DEVELOPMENT REVIEW BOARD
SUPPLEMENTAL SUBMITTAL

PROJECT NO. PR-2021-005459

SUBMITTAL DESCRIPTION: Response to DRB Comments Letter, Revised Site Plan and details addressing Transportation

**RE: PR-2021-005459 RESPONSE TO DRB COMMENTS
LOT 1A BLOCK 2 & LOT 2-A-1 BLOCK 2 SUNPORT PARK
2900 TRANSPORT ST NE**

SITE DETAILS

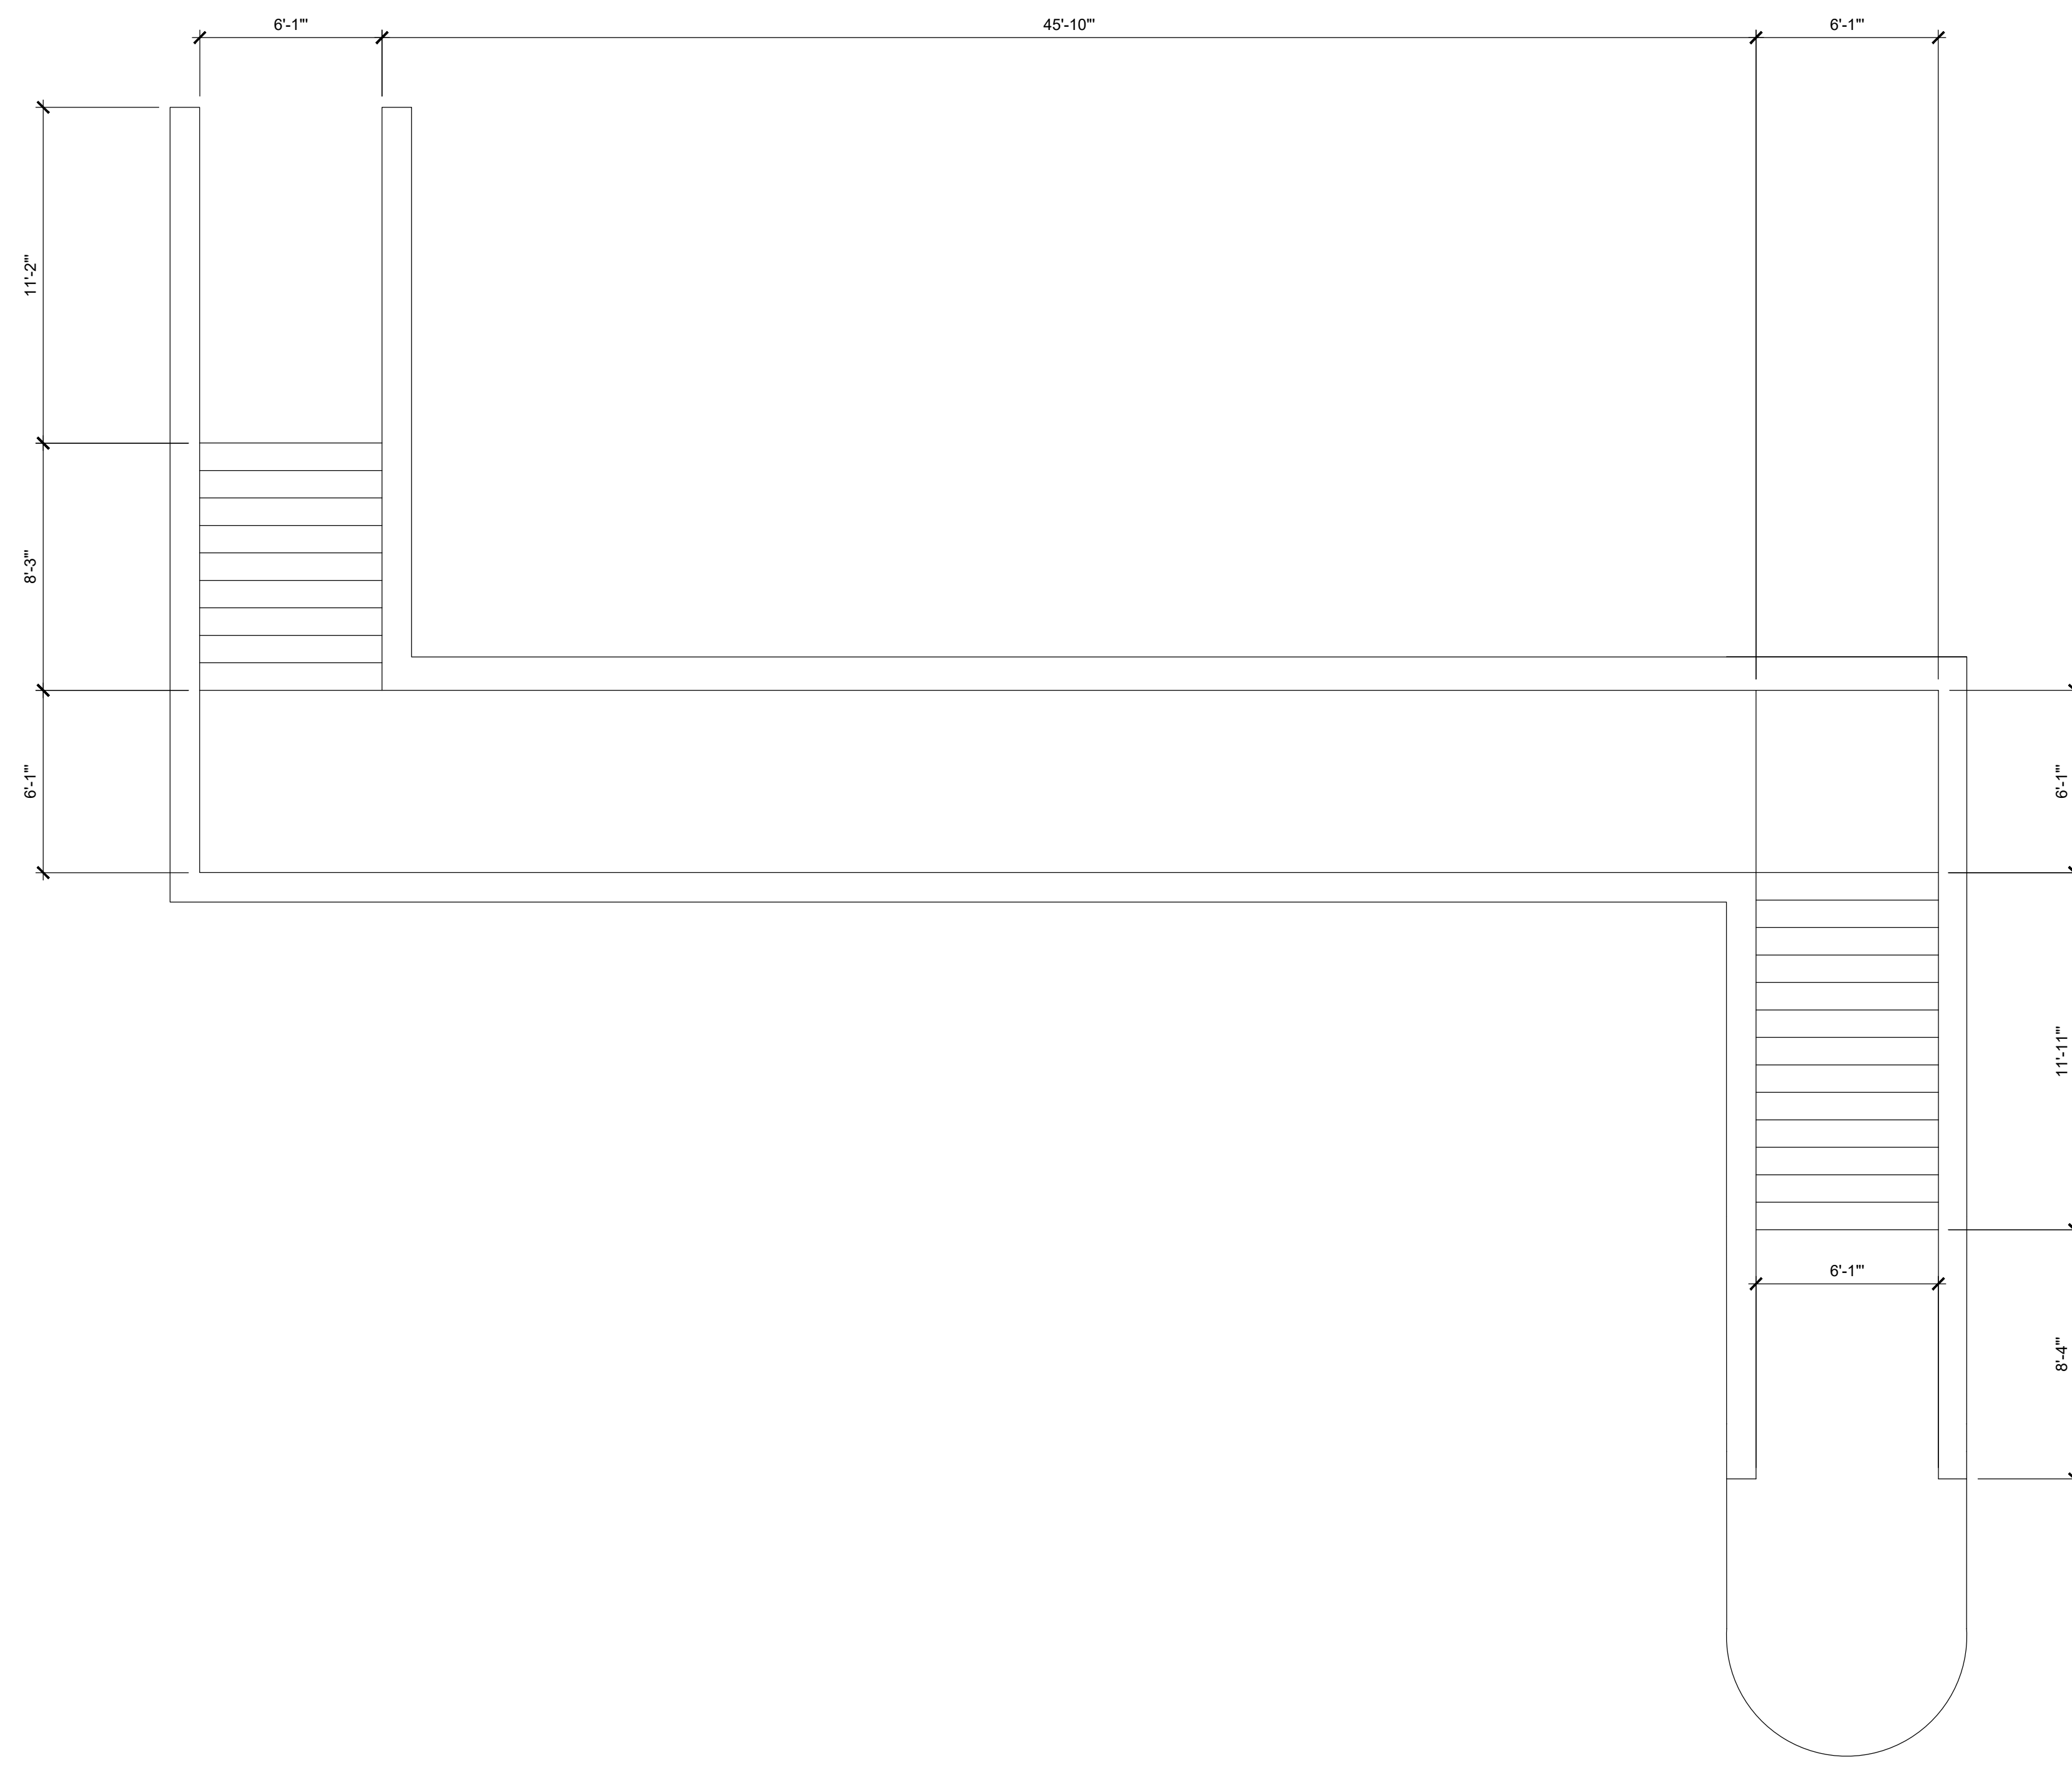
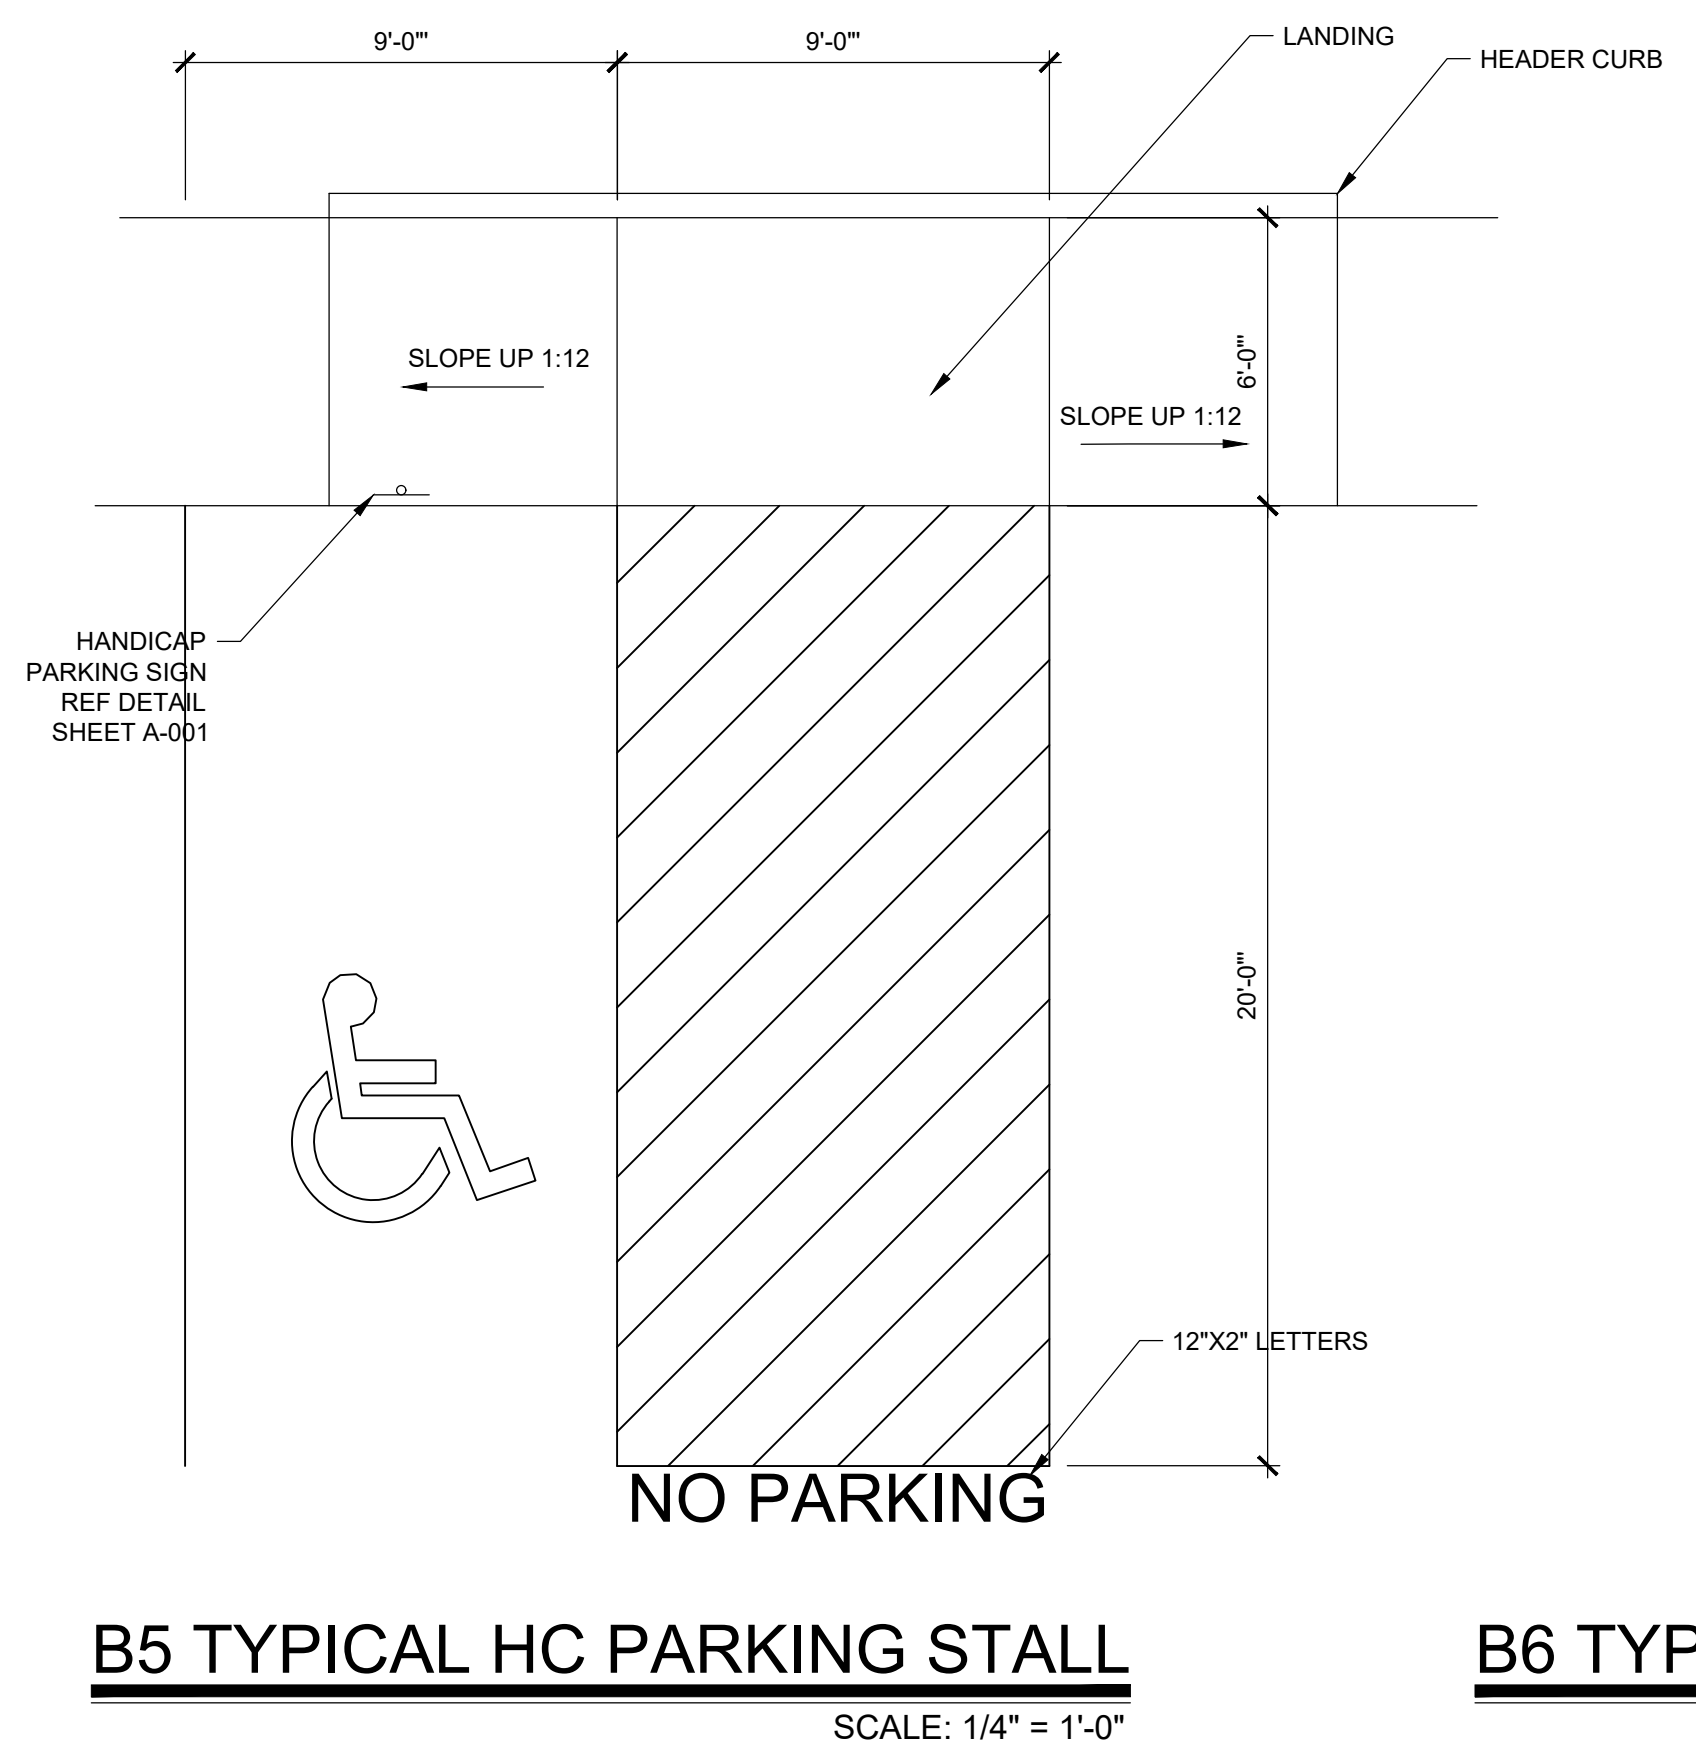
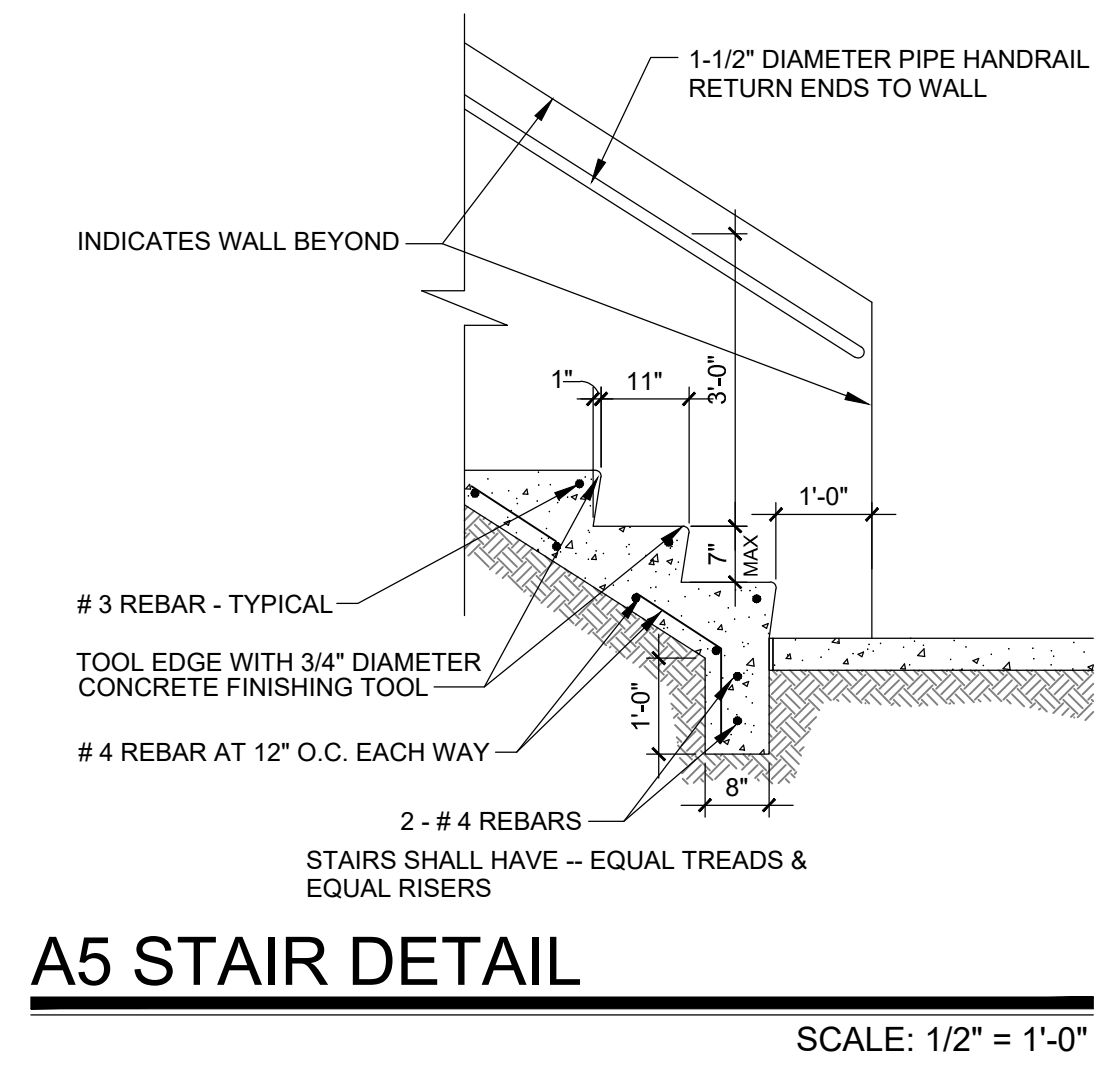
RESPONSE: Roadway dimensioning has been revised on Sheet A-001 with an architectural stamp date of 10/14/21.
2. For Keyed Note K on the turndown edges, these would typically apply to areas along the parking lot. Make a distinction with keyed note between areas that have turndown edges versus no turndown edges. Provide a detail for the sidewalk turndown edge, too.

RESPONSE: Bicycle parking spaces and quantities have been added to the site plan.
4. The ADA access aisle shall have the words "NO PARKING" in capital letters, each of which shall be at least one foot high and at least two inches wide, placed at the rear of the parking space so as to be close to where an adjacent vehicle's rear tire would be placed. (66-1-4.1.B NMSA 1978)

RESPONSE: Keyed Note K has revised wording and references to a turndown detail D6 on sheet A-002. Keyed Note X was added referencing a sidewalk without a turndown and a detail on D5 on A-002.

RESPONSE: "NO PARKING" added to detail B5 on A-002.
